ITEM # 1 Scott Bowles requests Concept Plan approval for multi-family housing in a proposed ITOD zone, located at 1200 S Towne Center Blvd. East Bay Neighborhood. Brandon Larsen (801) 852-6408 jblarsen@provo.org PLCP20210076

ATTACHMENT 4 – Elevations

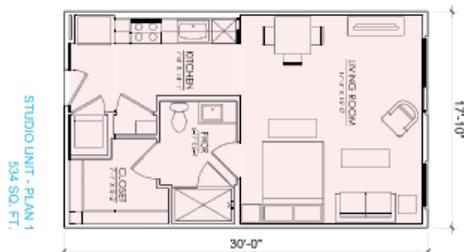
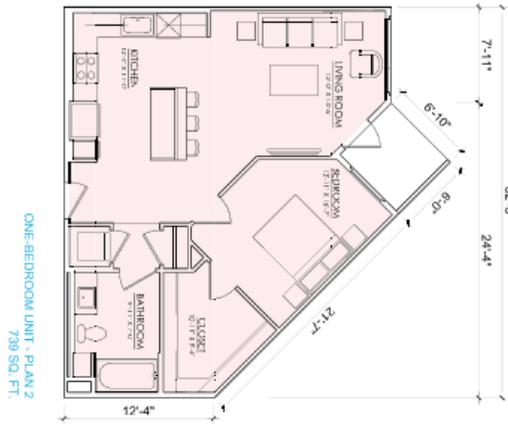
Elevations provided by the applicant are those for another project. The applicant has stressed that the submitted, conceptual plans and drawings are indeed conceptual and that plans will be further ironed-out in the future. The applicant did not provide elevations or floor plans for the proposed townhomes.
